ADDENDUM NUMBER 1

NOTIFICATION DATE:	BID TITLE:	BID NUMBER:	BID OPENING DATE & TIME:
4/04/12	City of Naples – Sidewalk Installation River Park	033/12	04/16/12 2:00PM

**CROSS-SECTION
B-B**

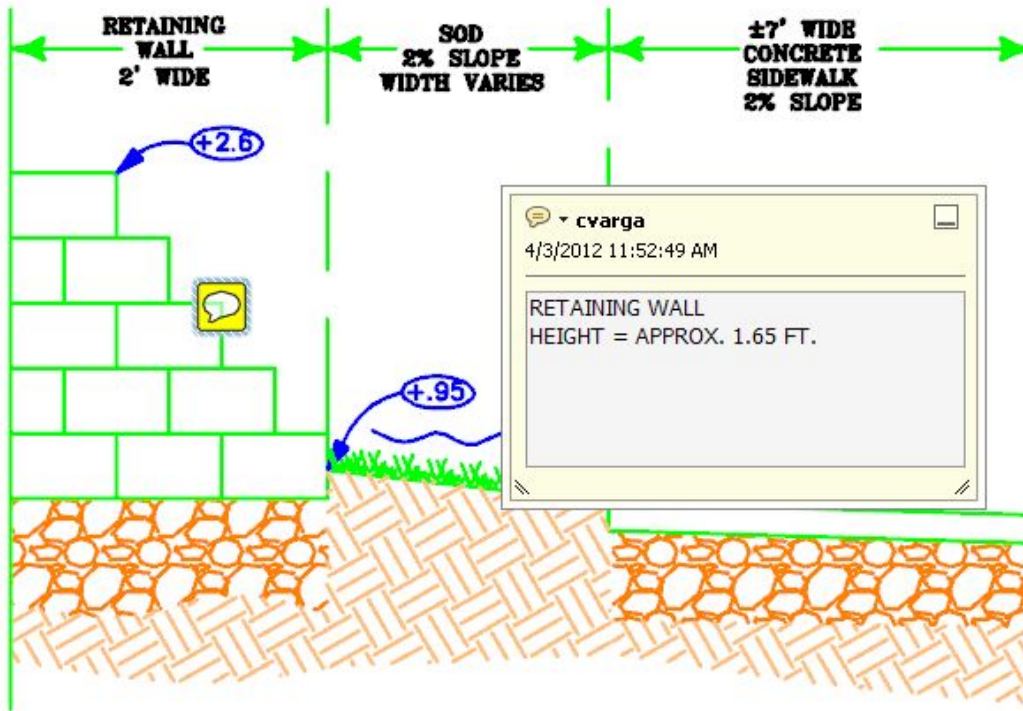
1. In review of the plans there is no detail of the construction of the retaining wall can the City provide a detail?

Attached

HEIGHT: 1.65 FT
LENGTH: 35 FT
WIDTH: 2 FT

THIRD AVENUE NORTH SIDEWALK GRADING PLAN

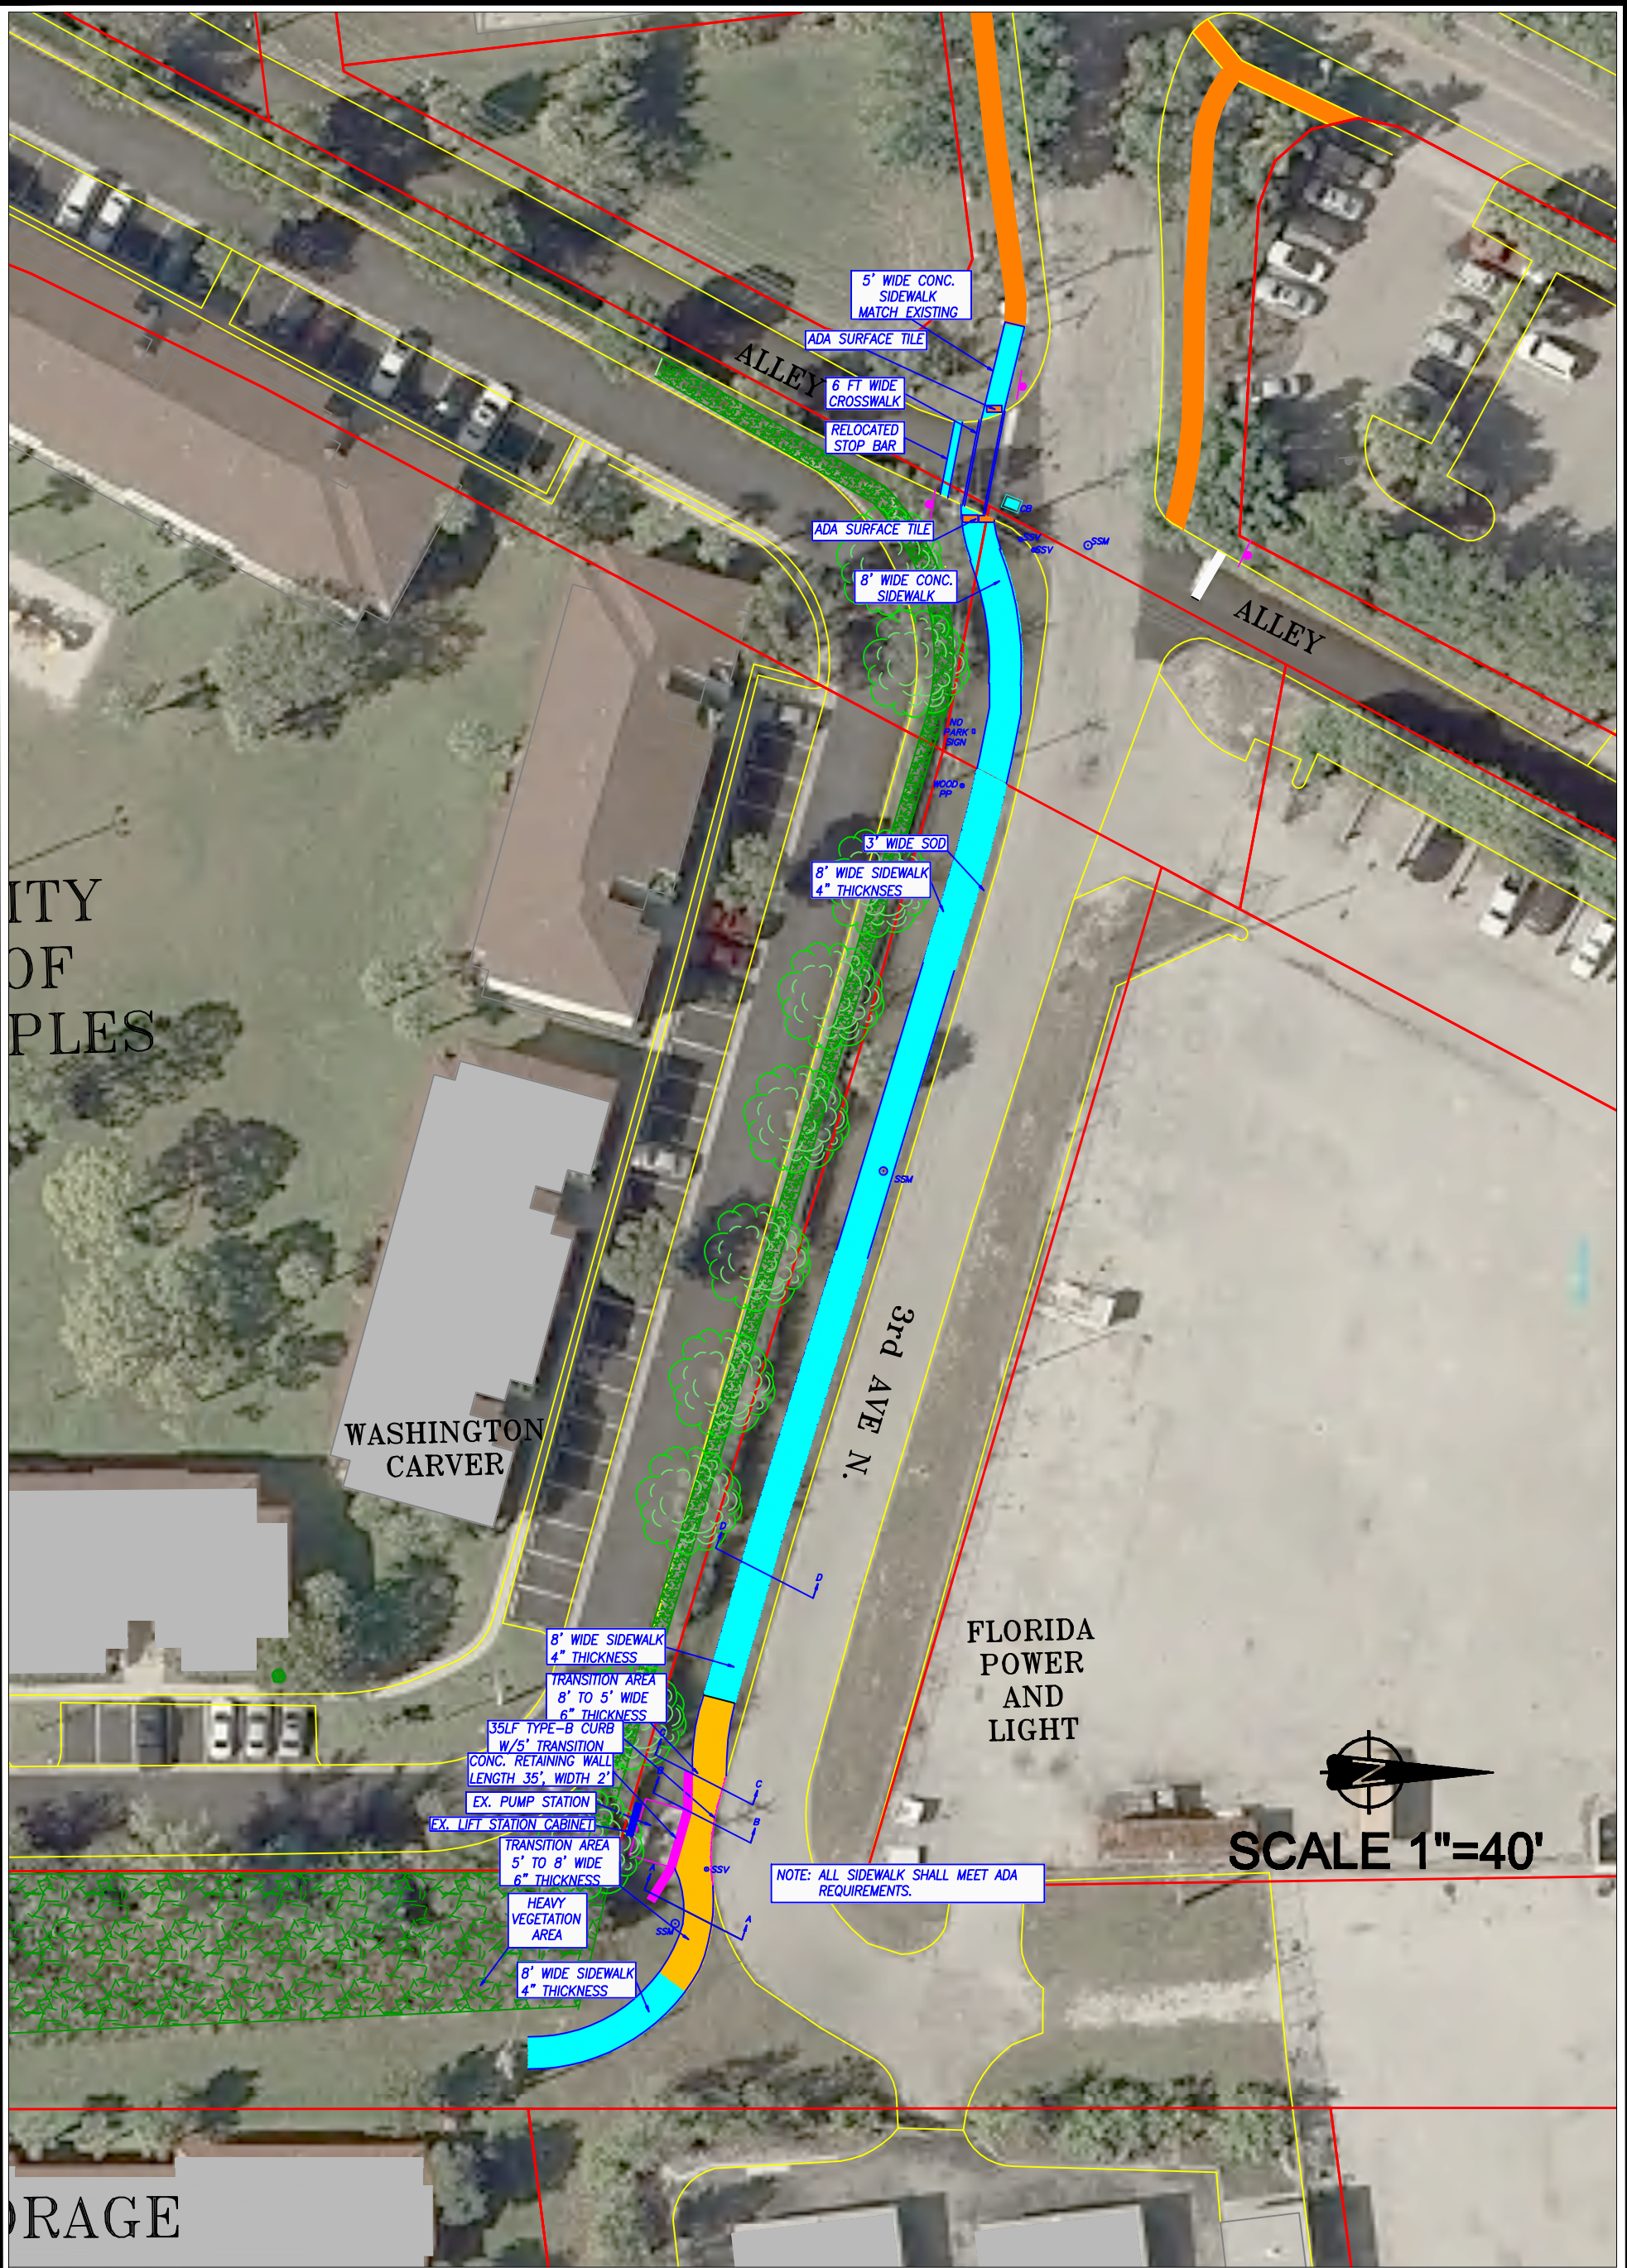
3. As per note 2 on the Grading Plan. Can all the material excavated be placed along 12th street?

8. Will the excess material be going to 12th St North ROW that is adjacent to this project?

Yes, with placement subject to direction of engineer provided that the material is acceptable.

Disposal of the excavated material shall be by placement along the west side of the unimproved portion of the 12th Street corridor extending southerly from the City's sewer pump station an approximate distance of 150 feet, more or less, with a nominal width between 10'-15', a height of up to 12" above existing grade and subject to direction of the Project Engineer.
